**SUBDIVISION REVIEW SHEET****CASE NO.:** C8J-2022-0177.1A**P.C. DATE:** October 25, 2022**SUBDIVISION NAME:** Easton Park Section 4B-East Phase 1 Final Plat**AREA:** 13.769 acres**LOT(S):** 2 total lots**OWNER/APPLICANT:** Carma Easton, LLC  
(AJ Zorn)**AGENT:** Carlson, Brigrance & Doering, Inc.  
(Charles Brigrance)**ADDRESS OF SUBDIVISION:** William Cannon Drive**GRIDS:** L12**COUNTY:** Travis**WATERSHED:** N. Fork Dry Creek**JURISDICTION:** Limited Purpose**EXISTING ZONING:** Planned Unit Development (PUD)**MUD PLAN:** Pilot Knob MUD**VARIANCES:** None**PROPOSED LAND USE:** 2 lots -1 mixed residential per PUD, open space/greenbelt**SIDEWALKS:** Sidewalks will be provided along all internal streets and the boundary street.

**CITY OF AUSTIN – TRAVIS COUNTY – SINGLE SUBDIVISION OFFICE  
SUBDIVISION APPLICATION – MASTER COMMENT REPORT**

CASE NUMBER: C8J-2022-0177.1A  
 REVISION #: 00 UPDATE: U0  
 CASE MANAGER: Sue Welch PHONE #: 512-854-7637

PROJECT NAME: Easton Park 4B East Phase 1  
 LOCATION: 7508 FM 1625 RD

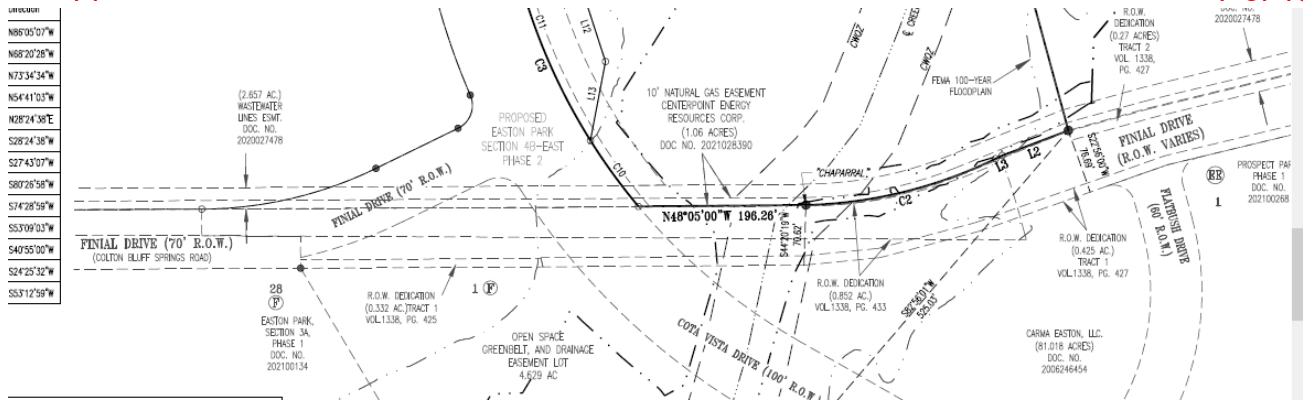
AD7: Please include the roadway and label **FM 1625 RD** in the location map as seen here in the location map

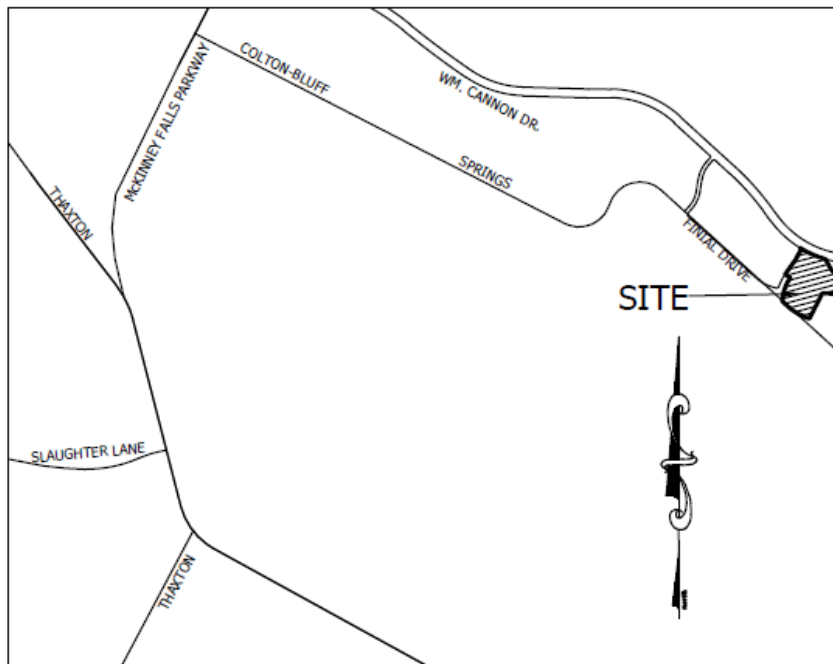
AD8: Please remove the label **COLTON BLUFF SPRINGS RD** underneath the label FINIAL DRIVE

AD9: FINIAL DR east of COTA VISTA DR is seen as breaking street name continuity, please clarify the intention
